Re: Montague Wind Power Facility Change Request #3 – Proposed Site Boundary and Transmission Line Route Modifications

Supplement to Change Request #3

Figure 1
Montague Proposed Modifications to
Approved Site Boundary and
230-kV Transmission Line Corridor
Montague Wind Power Facility -
Change Request #3

Figure 4
Nonirrigated Soil Capability Classes
Montague Wind Power Facility -
Change Request #3

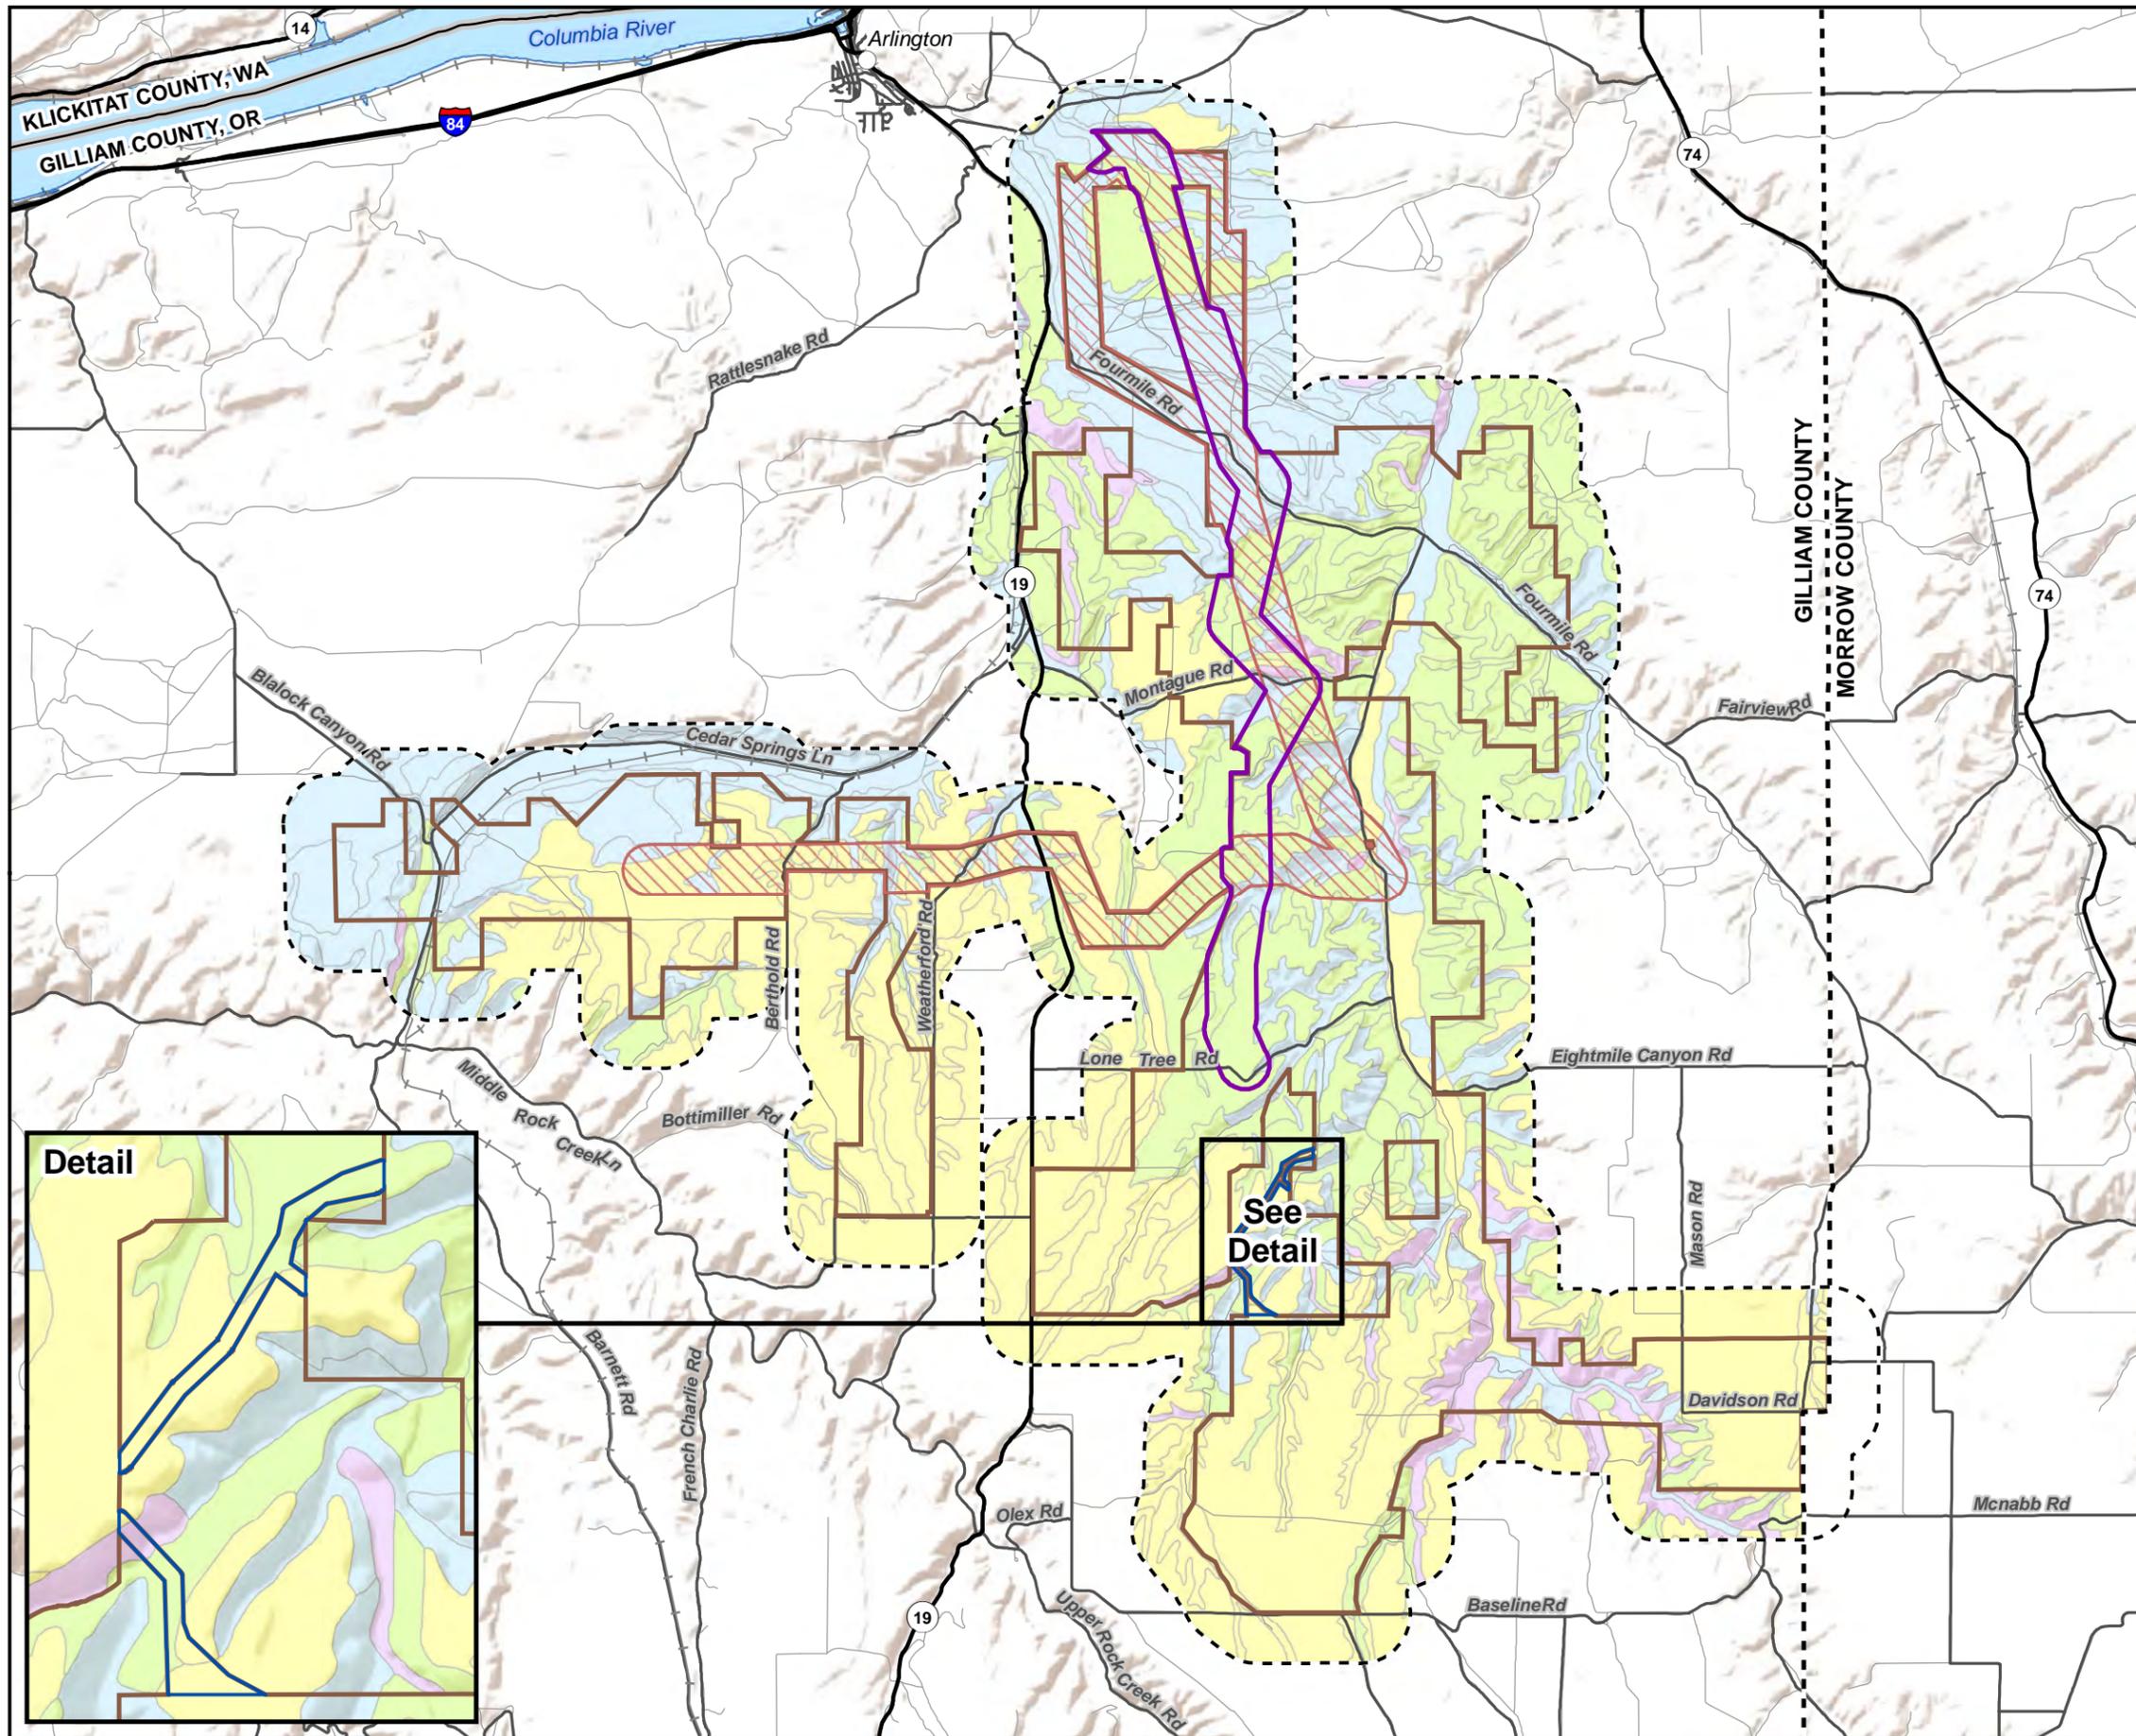
Montague evaluated the technical and engineering feasibility of possible alternative transmission routes on non-high-value farmland or nonarable land within the site boundary. Figure 4 shows that the soils within the site boundary are varied, with Class 3, 4, 6 and 8 being intermixed in the north and northeastern portion of the site boundary. The Facility substation must be located near the center of the site boundary and any transmission line route must run north to the BPA Slatt Substation. WGS habitat is widespread through the northern portion of the site boundary and the existence of Category 1 WGS habitat is the predominate factor in evaluating the technical and engineering feasibility of any transmission line route. In order to avoid Category 1 WGS habitat, the modified transmission line route is sited preferentially on land used for dry-land wheat farming. Further, there are geographic limitations including gullies, ravines, and steep slopes within the area that limit the technical and engineering feasibility of reasonable alternatives. The transmission line must also be setback for

In the change request, the certificate holder evaluated the NRCS soil classification for soil types within the proposed modified transmission line route/corridor and, as depicted on Figure 4, predominately includes Class IV and VIII nonirrigated soils, which would not be considered high-value farmland under ORS 195.300(10)(a). However, the certificate holder explains that “a portion of the route contains arable land” and that the line route has been “sited preferentially on land used for dry-land wheat farming.” “Arable land” refers to lands that are cultivated or suitable for cultivation.¹² Non-irrigated Class IV soils would be considered suitable for cultivation; non-irrigated Class V through VIII would generally be considered not suited for cultivation.

**Figure 5
Habitat
Montague Wind Power Facility -
Change Request #3**

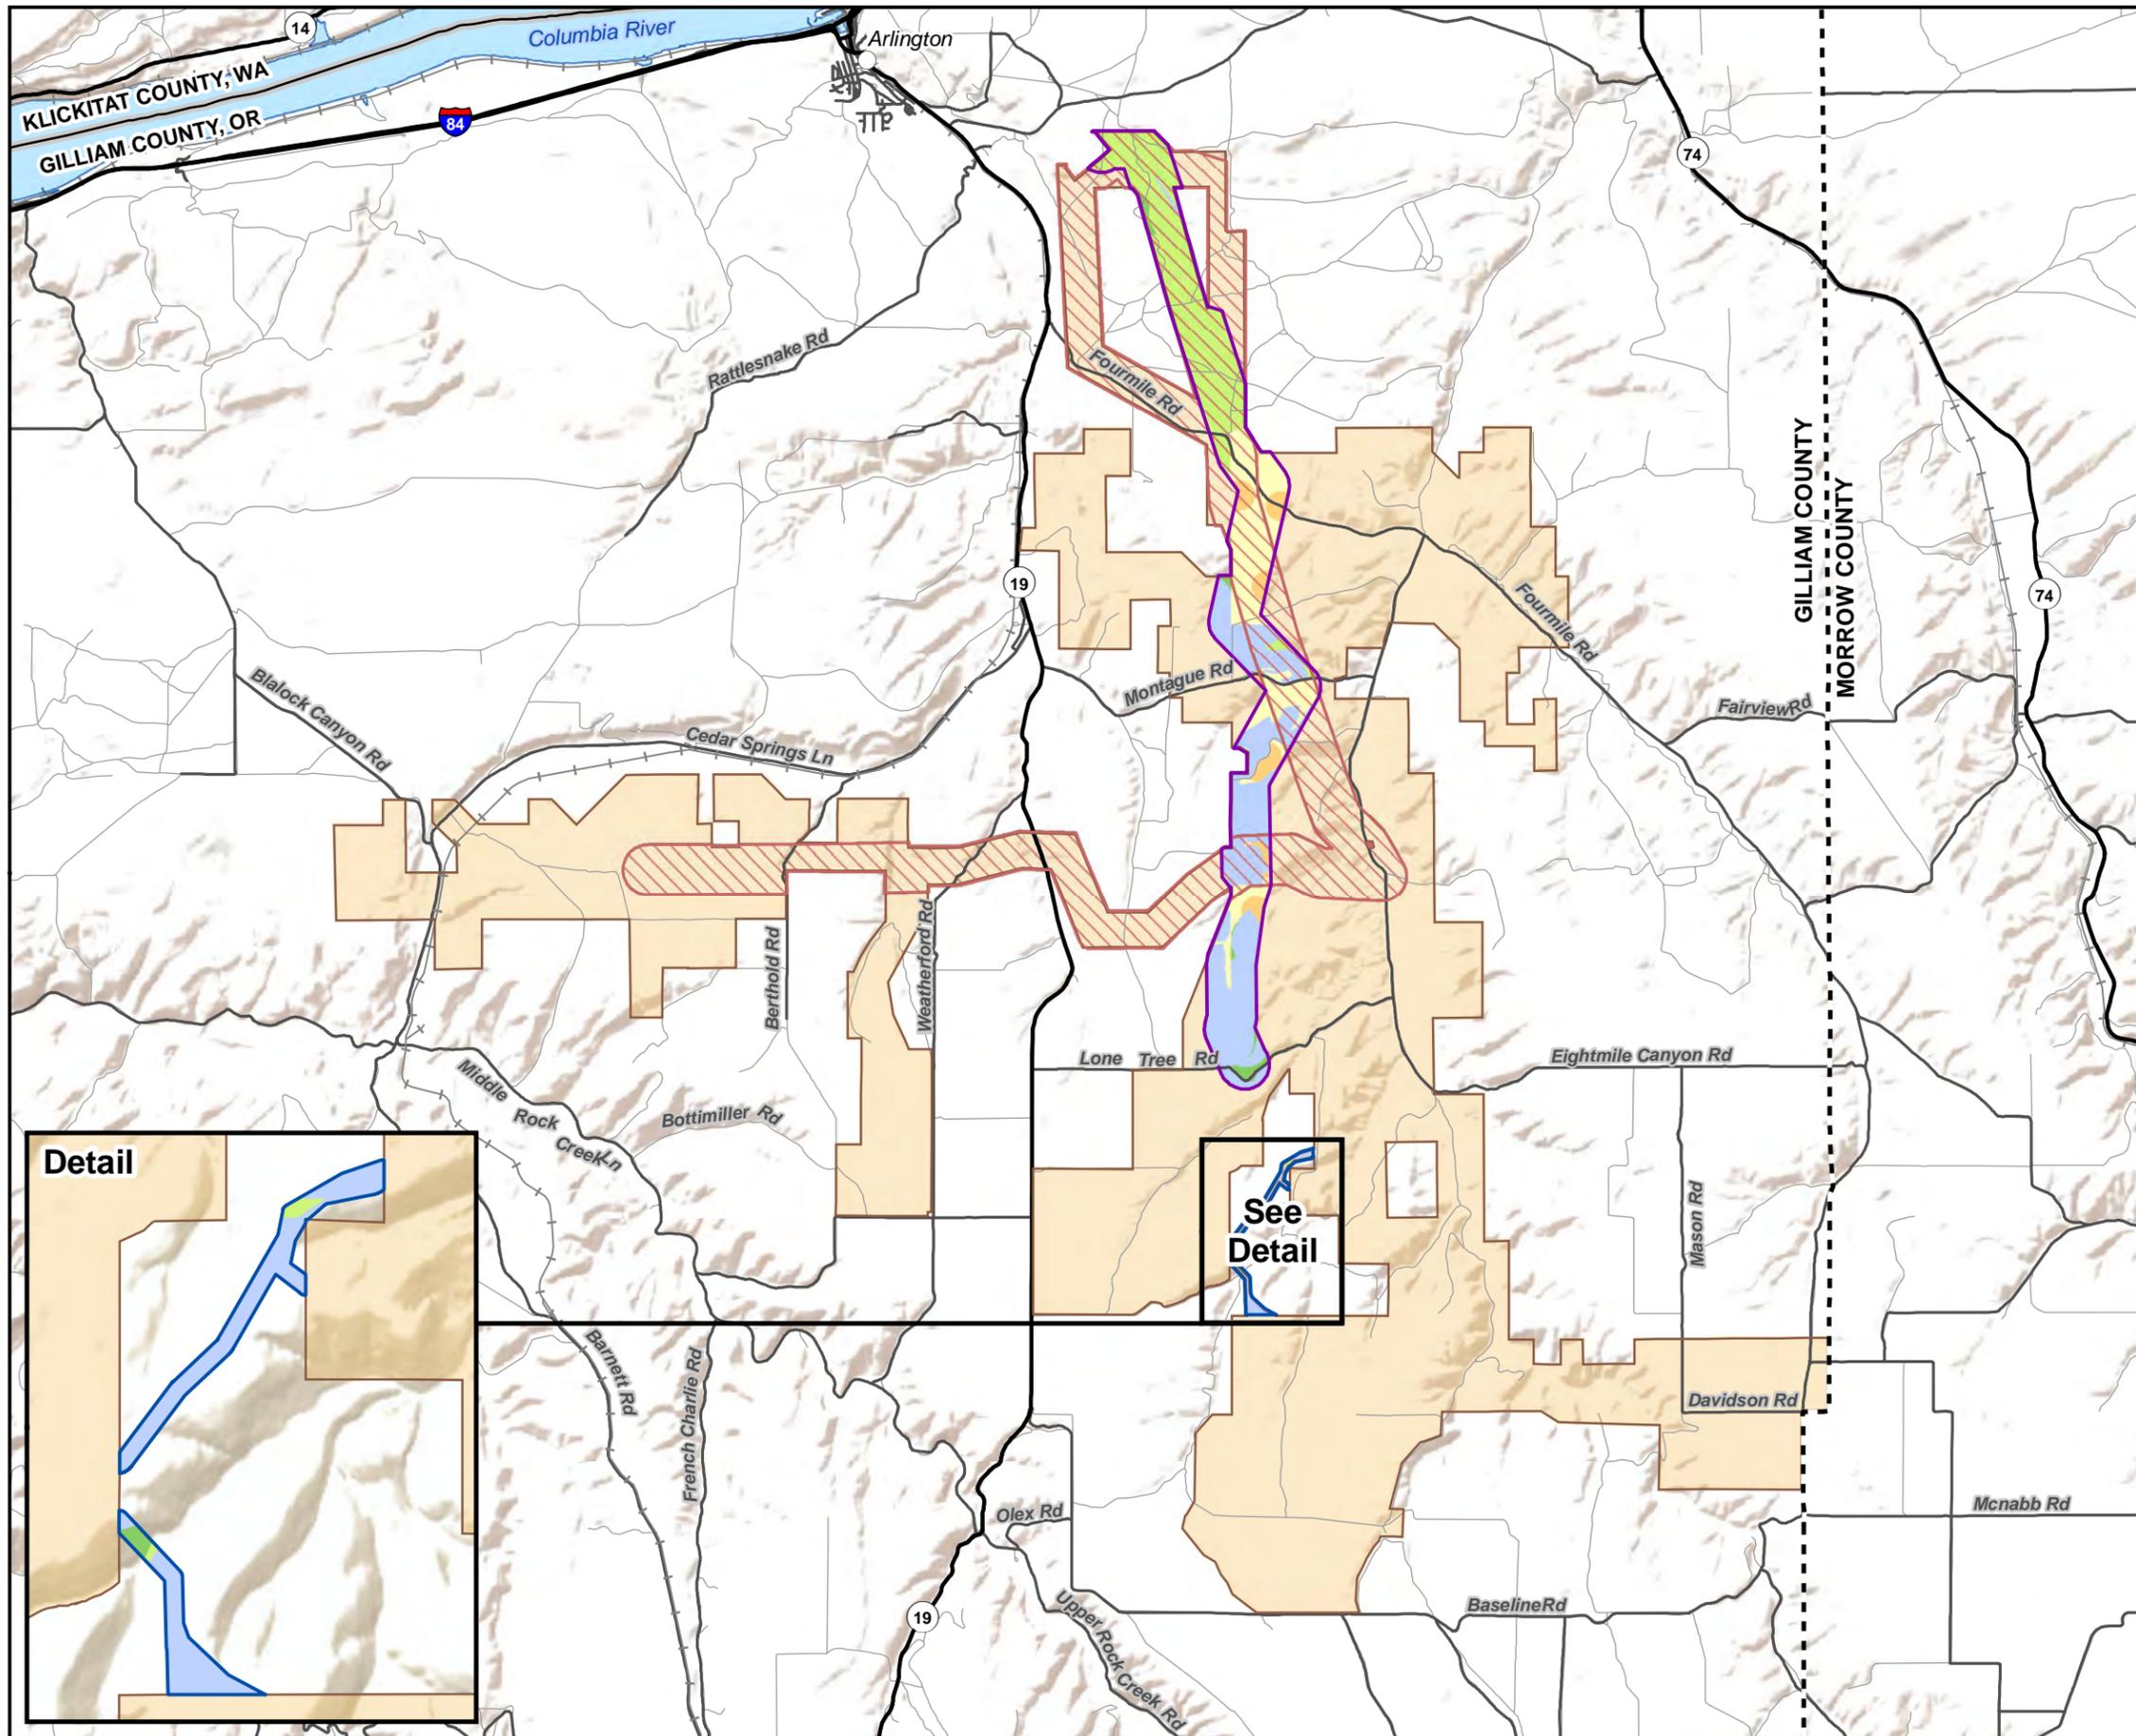
The habitat type within the proposed site boundary additions (see Figure 5) is mostly farmland (i.e., Category 6) with small areas of grassland and shrub-steppe. No aquatic habitats are present within the proposed site boundary additions.

The site boundary changes described in this request will consist of permanent disturbance of up to 0.20 acre of Category 3 shrub-steppe and native grassland habitat, 0.28 acre of Category 4 nonnative grassland habitat, and 3.37 acres of Category 6 dryland wheat habitat. Temporary impacts within the proposed modified site boundary will total 16 acres. Compared to the previous collector line and access road layouts the proposed changes will decrease the overall impacts to essential (i.e., Category 2), limited (i.e., Category 3), and important (i.e., Category 4) habitats, which is consistent with ODFW habitat mitigation standards and goals. In addition, the proposed turbine string access roads across Category 6 habitat will avoid the needed for constructing access roads on steep canyon slopes and thereby minimize environmental impacts to sensitive habitat mapped 2017 preconstruction surveys (i.e., WGS surveys, raptor surveys, and rare plant surveys).
